Re: ZMAP 2010-0001 and SPEX 2010-0003, HS-7 Dulles South and Elementary School, Goshen Road Assemblage, Revised SPEX Plat to Address Referral Comments

Re: ZMAP 2010-0001 and SPEX 2010-0003, HS-7 Dulles South and Elementary School, Goshen Road Assemblage, Response to Second Review Referral Comments

**Loudoun County Public Schools
HS-7 Dulles South and Elementary School
ZMAP 2010-0001, SPEX 2010-0003
Response to Second Referral Comments
July 22, 2010**

Figure 1 Gum Spring Road and Braddock Road

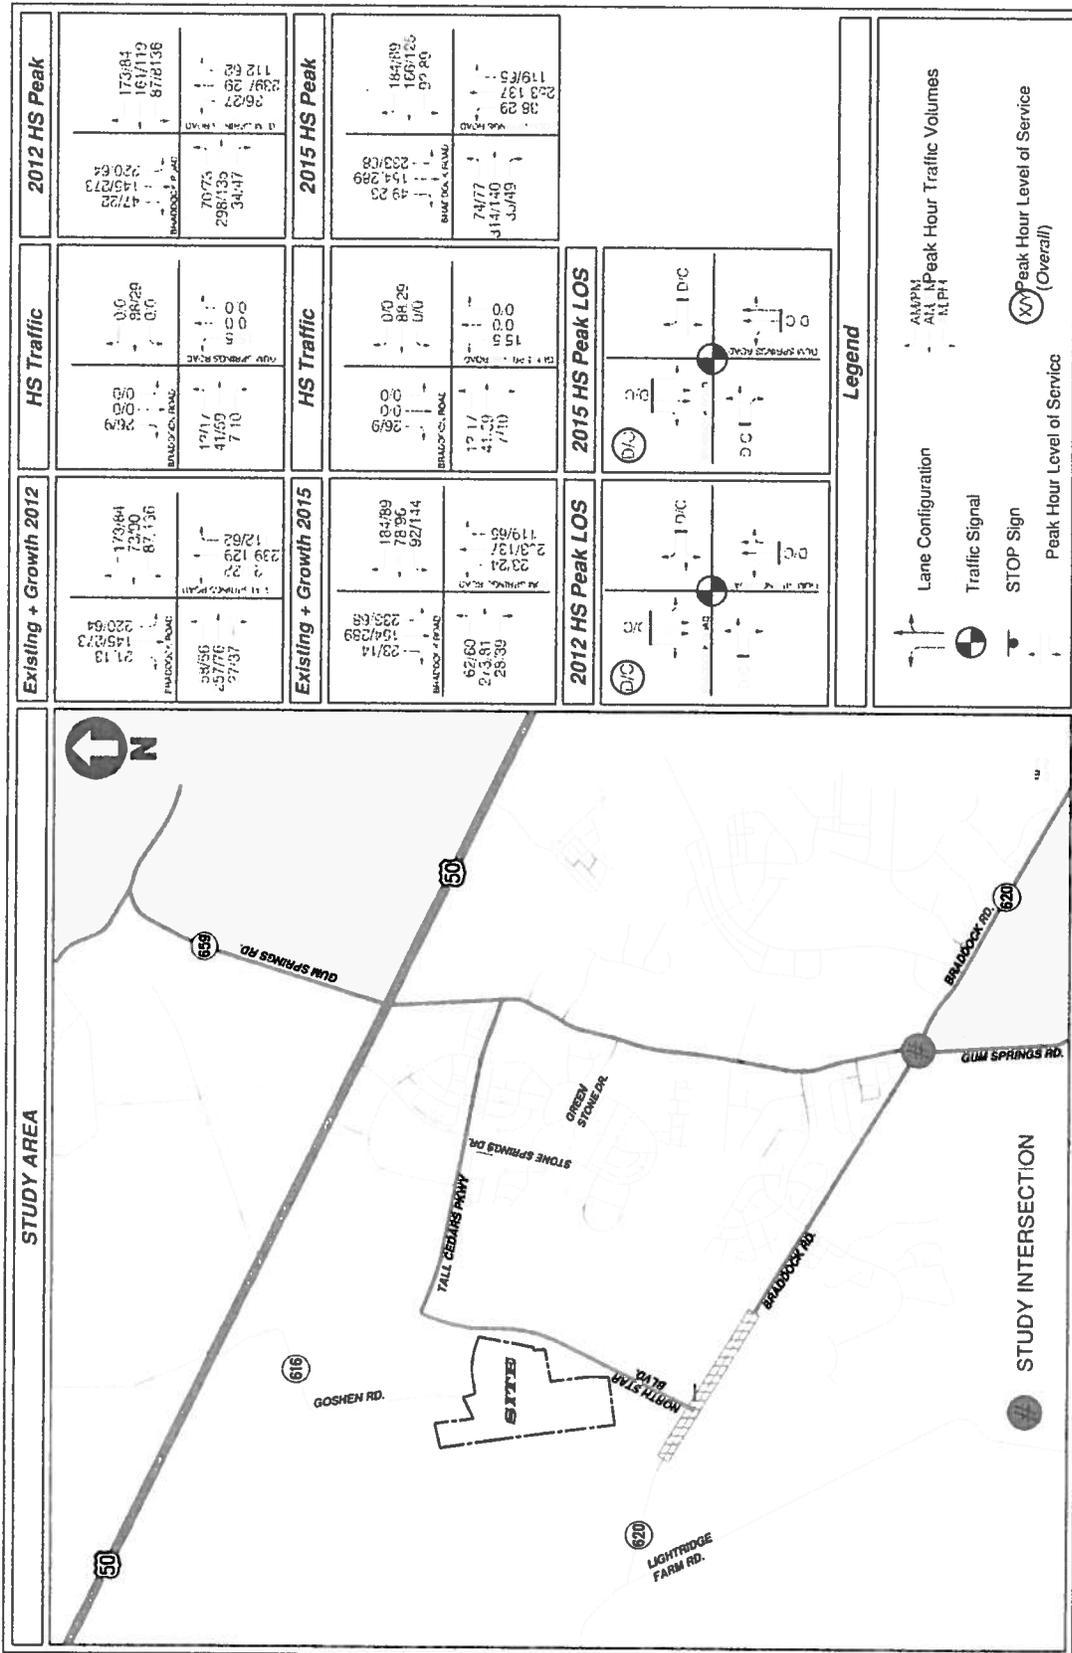
Comment 6: If not already constructed by others prior to the opening of the high school in 2012, the Applicant should construct the turn lanes recommended by the traffic study at the Gum Spring Road/Braddock Road intersection. Any necessary modifications to the existing traffic signal at this intersection should also be the responsibility of the Applicant if such modifications have not already been made by others. The Applicant should seek

Response: As discussed in our July 21, 2010 meeting, the traffic study accounted for traffic generated by planned developments in the vicinity of the proposed schools. Hence, as traffic from the planned developments was accounted for, similarly the proffered roadway improvements by these planned developments were also assumed to be in place for the analysis years. As outlined below, the following improvements, which are not in place, were identified in the traffic study under the high school opening year (2012) at the intersection of Gum Spring Road/Braddock Road:

As stated above, the traffic study incorporates trips generated by the developments that have proffered to provide these improvements. However, if the trips generated by the background developments in the area are eliminated from the analysis, and an analysis of the intersection is conducted utilizing the existing traffic, the inherent growth (regional traffic increase) and the trips generated by the schools, the improvements listed above are not required. The technical memorandum confirming this finding, prepared by Gorove/Slade Associates dated July 22, 2010, is included for staff consideration. Based on this memorandum, LCPS asks that the intersection improvements (outlined above) be appropriately provided by those developments that have proffered these improvements as these improvements are not needed to facilitate safe and adequate access to the proposed schools.
